Access Compliance Report Public Rights-of-Way (Curb Ramps)

Main Street: OSO_PKWY		Cross Street: MEANDERING_TRAIL		Location: SE
ADA ID: RPRK211019151738	Ramp Type: Type 4 - Parallel	Initial Pass/Fail: Fail	Overall Compliance: No	Severity Score: 45

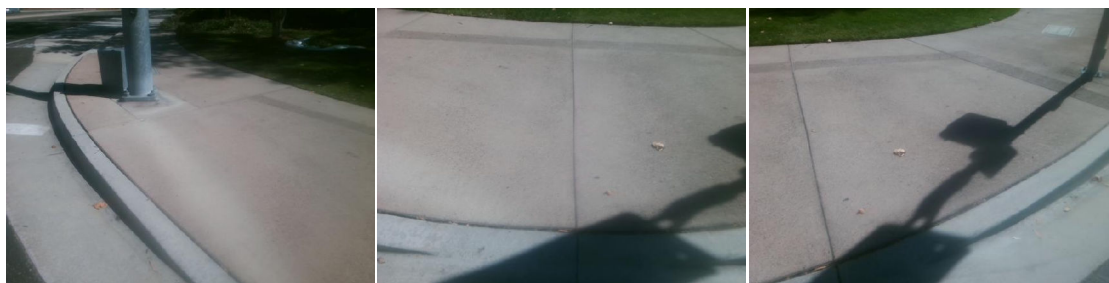
Compliance	Description	Data	Compliance	Description	Data
N/A	Ramp Length LT (in)	122	N/A	Ramp Length RT (in)	112
Yes	Ramp Width LT (in)	100	Yes	Ramp Width RT (in)	100
No	Ramp Run Slope LT (%)	8.4	Yes	Ramp Run Slope RT (%)	6.3
No	Ramp Cross Slope LT (%)	8	No	Ramp Cross Slope RT (%)	7.4
N/A	Landing Present	N/A	N/A	DWS Provided	N/A
N/A	Landing Length (in)	N/A	N/A	DWS Contrast	N/A
N/A	Landing Width (in)	N/A	N/A	DWS Length (in)	N/A
N/A	Landing Run Slope (%)	N/A	N/A	DWS Full Width	N/A
N/A	Landing Cross Slope (%)	N/A		DWS Offset Type	N/A
N/A	Landing Movement Obstructed?	N/A	N/A	DWS Offset Left (in)	N/A
	Landing Movement Type	N/A	N/A	DWS Offset Right (in)	N/A
N/A	Landing Shared	N/A			
N/A	Clear Space	Yes			
N/A	Clear Space To Crosswalk (in)	48			
N/A	Marked Crosswalk 1	Yes	N/A	Marked Crosswalk 2	Yes
	Crossing 1 Direction	N		Crossing 2 Direction	W
	Marked Crosswalk 1 Width (in)	144		Marked Crosswalk 2 Width (in)	144

N/A	Ramp Inside Crosswalk 1	Yes	N/A	Ramp Inside Crosswalk 2	Yes
	Crossing 1 Slope (%)	5.6		Crossing 2 Slope (%)	5.3
	Crossing 1 Cross Slope (%)	8		Crossing 2 Cross Slope (%)	5.5
N/A	Gutter Ponding	N/A	N/A	Curb Slope	16.5
Yes	Gutter Lip Height (in)	0		Road Run Slope (%)	7
N/A	Gutter Run Slope (%)	N/A		Road Cross Slope (%)	6.8
N/A	Gutter Cross Slope (%)	N/A	No	Perpendicular Joint Present	No
Yes	Overall Surface Condition	Acceptable			
	Cross Gutter Present?	No		Spandrel Present?	No
	Replace Cross Gutter?	N/A		Replace Spandrel?	N/A

Remove & Replace Curb Ramp With Two New Directional Ramps or Equivalent.

R204.3, R304.3.2, R304.5.3, STD 1115
